**400 E. Main Street
CERTIFICATE OF APPROPRIATENESS**

HISTORY/REQUEST: Certificate of Appropriateness (CofA) for roof, screen removal and new ADA ramp at 400 E. Main Street. House is to be converted from residential use to retail and office.

DATE OF REVIEW: October 19, 2021

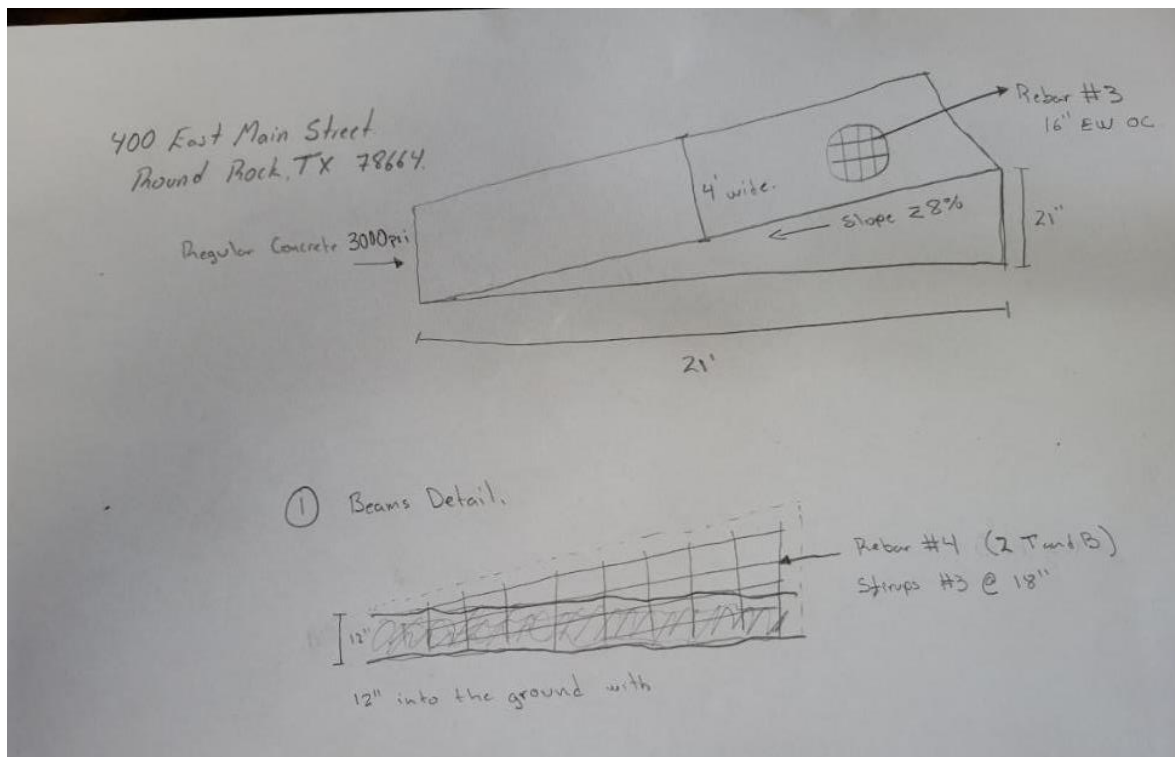
The applicant proposes adding a ramp to the north side of the west porch because of the proximity to a concrete pad at the rear of the property to be used for accessible parking. He prefers to use the side porch rather than the rear screened porch because the rear porch accesses the kitchen, which will not be an area intended for customer use.

The proposed ramp is described as being made of concrete with a simple pipe railing. The ramp would be 21 ft long, so it would end about halfway along the screen porch in back. Drawings appear to indicate that the porch wall would be removed to the left side of the steps and remain on the right side. A few inches gap would be left between the ramp and the foundation skirting. A simple pipe railing would be located on the street side of the ramp but not next to the house.

From this perspective Proposal A would not be acceptable because it would remove the entire perimeter wall on one side of the porch.

Staff also notes some potential problems with leaving a space between the ramp and the foundation skirting: wheels could slip into the gap and pulling weeds would be difficult. Since the skirting on this part of the house is stucco-textured fiber cement siding, it is not a historic feature and would not be compromised by being attached to the ramp.

Staff does not believe that Proposal A is an acceptable option because it is a more permanent and more impactful than the other options.

*Staff illustration of proposal B
based on verbal description*

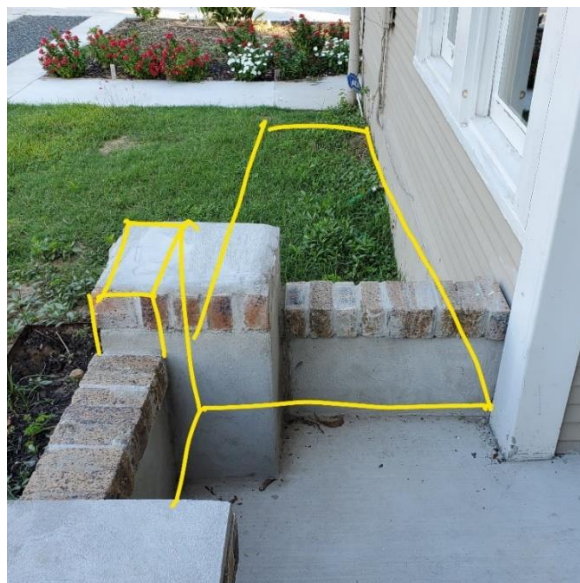
A building inspector pointed out that the porch is deep enough that the minimum 36" width could be achieved while removing only part of the porch wall, leaving a 4-6-inch-thick wall on the street side of the porch. Unfortunately, the contractor did not think he would be able to slice through the corner block (stucco over concrete block). However, preservation staff believe that there are reasons that the HPC might allow the applicant to remove the existing wall and build a narrower replacement:

- The porch is not original and was built in spring 2021 by the previous owner.
- The porch design is not identical to the previous porch: the original had corner blocks only at the corners of the porch, and the rebuilt porch also has blocks to either side of the steps. The stucco texture and brick are also different.
- The applicant has expressed concerns about the quality of the repair.

Proposal B would be acceptable because the west (street-facing) shape of the porch, including wall and steps, would be unaltered; however, it may not be technically feasible. Staff believes that it would be justifiable to allow the porch wall to be rebuilt in order to fit the ramp because of the opportunity to undo the features that were not part of the original porch: the extra corner blocks could be removed, the stucco texture could be roughened, and the overall workmanship could be improved upon.

Staff believes that Proposal B is a preferable option if construction is feasible. It lets the side of the porch facing the street remain in place and closer to the street than the ramp. It is an option that could remain in place for the rest of the house's commercial life and offers the possibility of reversing recent alterations.

Staff recommends that following conditions be added to the motion regarding Proposal B:

- If the porch wall is reconstructed, the alterations made in spring 2021 will be reversed so that it more closely resembles the original west porch.
- The edge of the porch wall should be distinct from the side of the ramp, distinguished by a scored line, a slight setback, and/or a change in texture.
- The ramp may be attached to the foundation skirting (but not the wood siding).

L: porch in 2020; R: porch in October 2021

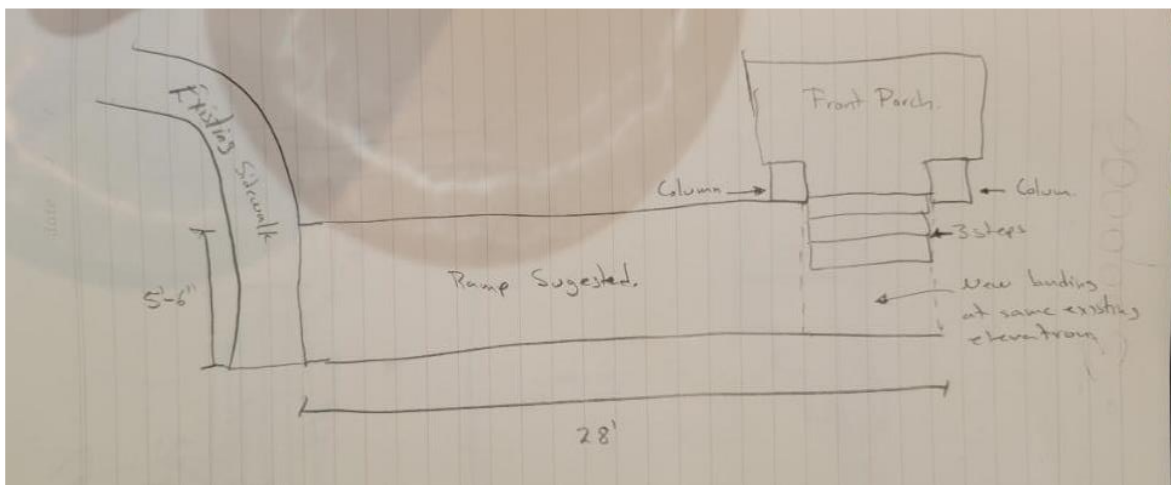
After determining that he couldn't cut through the corner block, the contractor offered a third proposal. This new proposal by the applicant was brought to staff the day before meeting packets were to be distributed to the HPC. In this proposal, the ramp would lead to a landing built over the existing steps in front of the porch. The diagram does not indicate whether this would be a ramp built over the existing steps, whether the steps would be replaced, or what the proposed material(s) would be.

Proposal C needs more detail in order to be fairly evaluated, but if constructed from wood without demolishing the steps could be the most reversible of the options. However, because it would be in front of the porch it would have a greater impact on its character. Staff believes it likely that the house will remain in commercial use for the remainder of its existence, so reversibility is not particularly relevant except that it would be preferable to options that would permanently affect its character.

Staff believes that not enough information about Proposal C has been provided to make a recommendation on it, but it may offer a more temporary solution if Proposal B is not feasible.

Staff recommends that the following conditions be added to the motion regarding Proposal C:

- The platform in front of the existing porch is to be constructed over the existing steps without removing them.
